Seagate Technology
10323 West Reno (West Dock)
Oklahoma City, OK 73127-9705
P.O. Box 12313
Oklahoma City, OK 73157-2313

10/13/99

John Lohmeyer
T10 Chairman

Subject: Proposal for Fast-160 to be included in SPI-4

Figure 44 - LVD timing measurement points for DT = Fast-160 data transfers

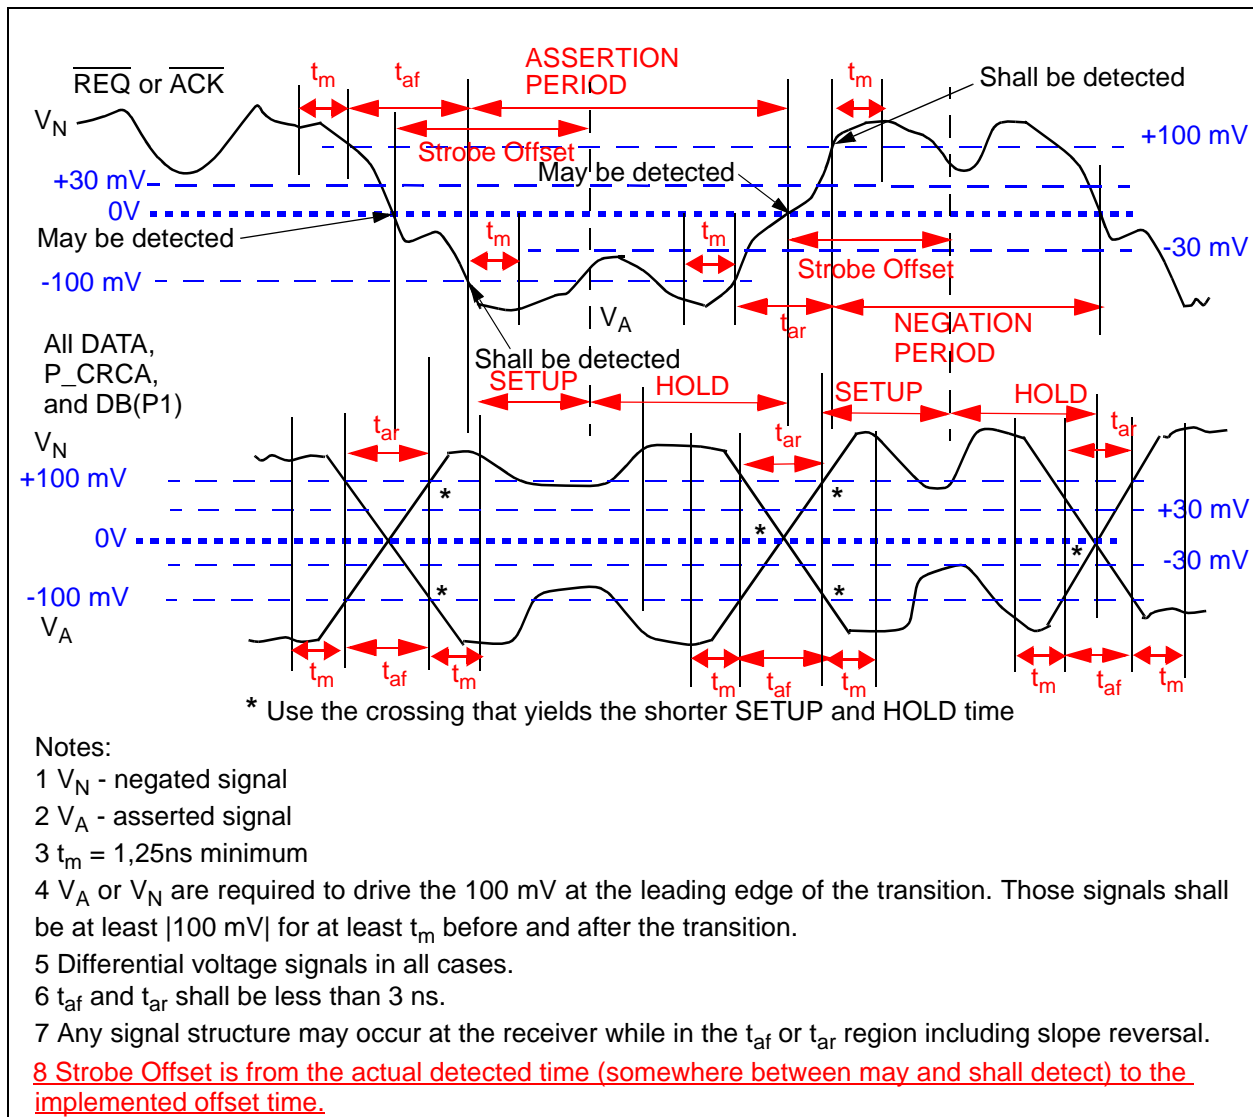
The signal shall transition from -100 to +100 mV or +100 to -100 mV in 0 to 3 ns, the waveform between -100 and +100 mV is not otherwise specified. Signals shall remain above the $|100\text{ mV}|$ level for 1,25 ns at each end of the transition. The signals shall not drop below $|30\text{ mV}|$ except during the transitions. Conditions exist with longer, loaded SCSI busses and irregular REQ and ACK pulse widths where long assertions or negations produce a much larger signal than short assertions or negations. This sets up an environment where the short REQ or ACK pulses may not have adequate timing margin unless the definitions in figure 44 and figure 43 are used in the measurement of timing parameters.

Figure 47 - Fast-160 Training Pattern

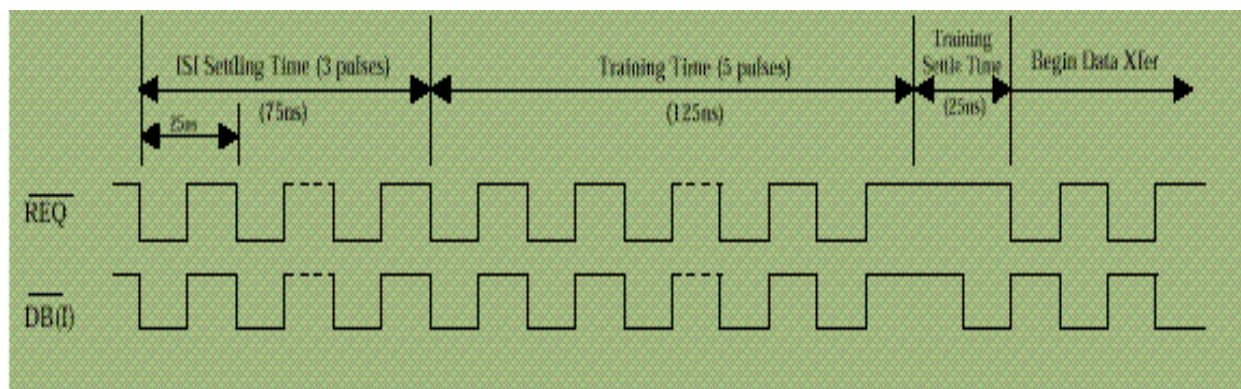
The training pattern for Fast-160 shall be transferred at the start of each Fast-160 data phase. Return ACK/REQ signals from the receiving SCSI device shall be ignored by the originating SCSI device during the training pattern. The training pattern for Fast-160 shall conform to Figure TBD. The receiving SCSI device shall use some or all elements of the training pattern to achieve deskewing. The transmitting device shall not make an intentional shift in relative timing between the databus and the ACK/REQ signal subsequent to the training pattern during the DT data phase. The requirement to not intentionally change relative timing does not include the effects of ISI or ISI compensation.

Figure N.1 illustrates a transmitter drive strength technique.

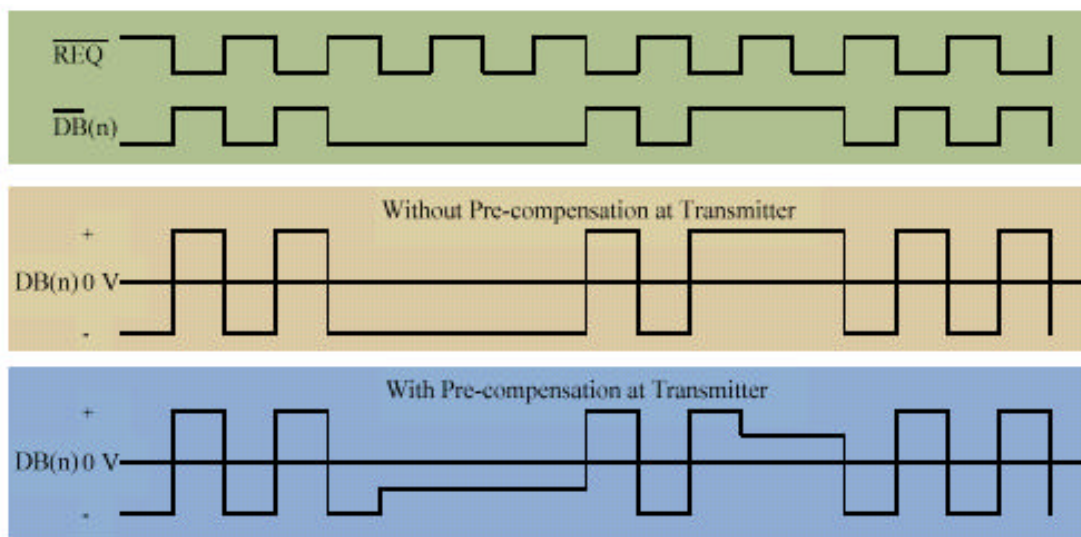
ISI compensation may be achieved by several techniques including time shifting and transmitter drive strength switching. The technique employed is vendor specific but SPI-4 requires that the technique achieves at least a 0,8 ns reduction in ISI at Fast-160.

Figure N.1 illustrates a transmitter drive strength technique.

Figure N.2 Example Deskewing Technique

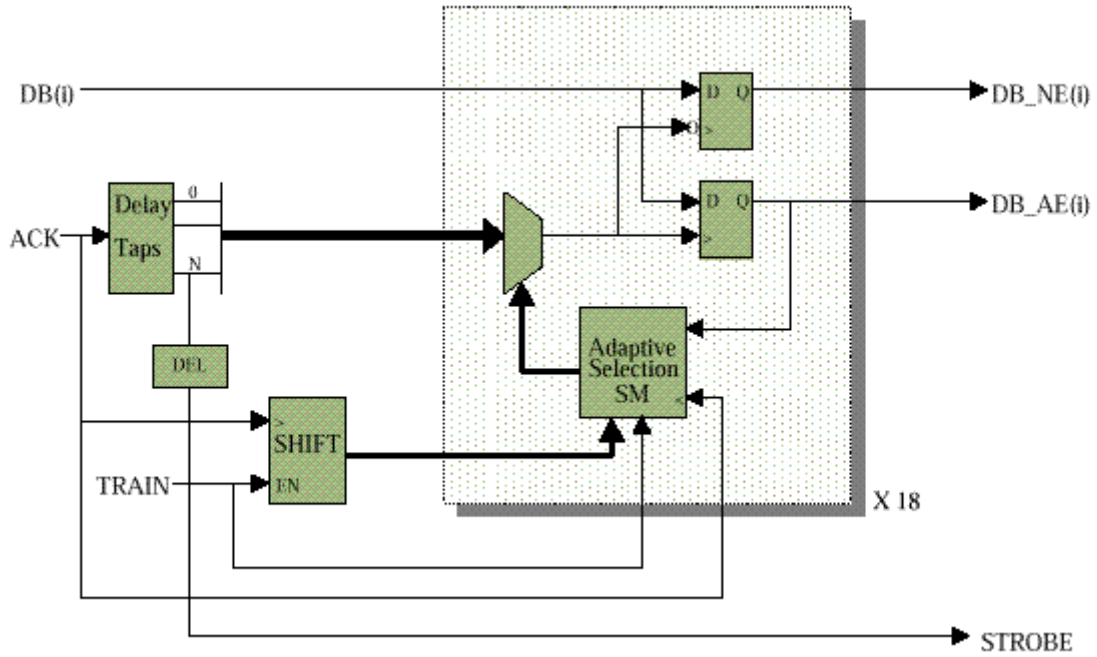
The deskewing technique used in the receiving SCSI device is vendor unique. Any technique that works with the SPI-4 specified training pattern and complies with the specified Receive Skew Compensation timing requirement is allowed. Figure N.2 illustrates such a technique. The training pattern is not available in Fast= \leq 80 and consequently deskewing is only used for Fast $>$ 80.

In this example the tap selection is based upon a binary search algorithm.
